ADDENDUM #10 TO:

**Project: ROK TAFE Consolidation Stg.2
- Design and Construct**

**Number: CQURFQ-26-4-DFM
Addendum Issue Date:
07/04/2026**

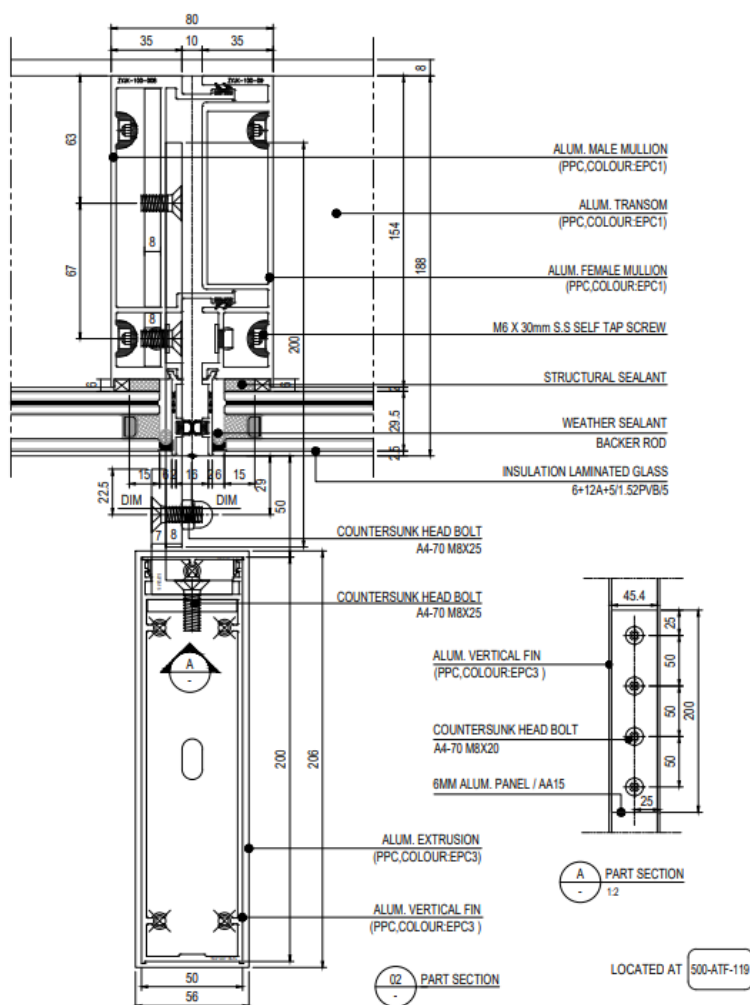
Can you provide further detail of the aluminium vertical shade fins, specifically how they are fixed to the glazing mullions.

We suggest a system similar to the below detail. A male / female mullion that includes a bracket allowing fixing of a fin that aligns with centreline of mullion. Size of fin – width to match width of mullion, length to suit ESD modelling (between 150mm – 250mm long) Finish to match mullion finish.
